Date Issued :	February 20, 2023	PCN Number :	513285
Reason for Change :	Change to Product		
Description of Change :	Change in drawings : This notification is to inform you about addition of suggested panel cutout information to the drawings. there is no form/fit/ functional impact to the parts		
Reason for Short Notice :	Special Request		
Assessment of Change :	No change to parts - Form/Fit/Function		
Planned Implementation Date :	March 31, 2023		
Sample Availability Date:	March 20, 2023		
Internal Molex Qualification Date :	March 20, 2023		
Last date to request Samples by Customer :	March 20, 2023		
Traceability Code Markings / Date :	No special marking on the product or packaging

Overview

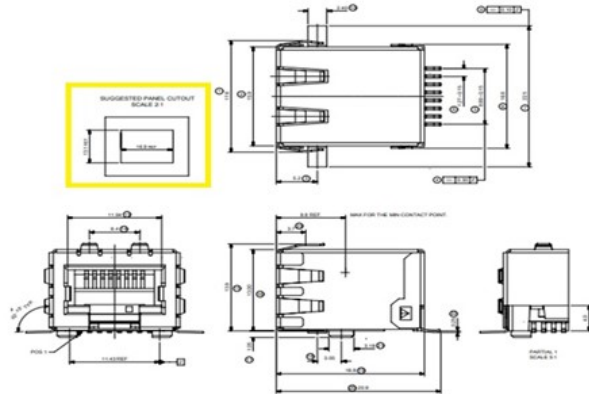
- Change in drawings : Addition of suggested panel cutout information to the drawings of series 85505, 85542, 85543 and 95622. No change in the affected products
